**RE: INTERIM AUDIT ADVICE LETTER NO. 1 - GILLIESTON PUBLIC SCHOOL REDEVELOPMENT AND NEW PUBLIC PRESCHOOL SITE AUDIT - REVIEW OF RAP**

Ref: 318002140

Audit Number: TO-139

- 'Remediation Action Plan, Gillieston Public School', Stantec, version Rev 5, 8 November 2024 (**the RAP**).

# Validation Sampling and Remediation Extents

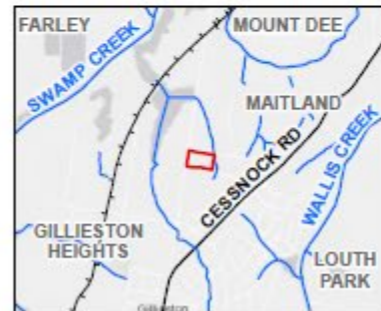
Description	Extent of Remediation Required	Preferred Options
Lead and zinc impacted soil (remaining from interim remediation)	Lateral: 'Approximate Initial Remediation Extent' outside of the hatched area on Figure 3 in the RAP ( <b>Attachment 3</b> ). Approximately 115 m <sup>2</sup> around existing buildings in the northwest portion of the site. Vertical: Estimated to be 0.3 mbgl, depth of fill.	Excavation and Offsite Disposal, or Cap and Contain
Lead and zinc impacted soil (additional remediation area identified in DSI)	Lateral: 'Approximate Additional Areas Requiring Remediation' on Figure 3 of the RAP ( <b>Attachment 3</b> ). Approximately 197 m <sup>2</sup> around the interim remediation area and inferred to extend under buildings. Vertical: Estimated to be 0.4 mbgl, depth of fill.	Excavation and Offsite Disposal, or Cap and Contain
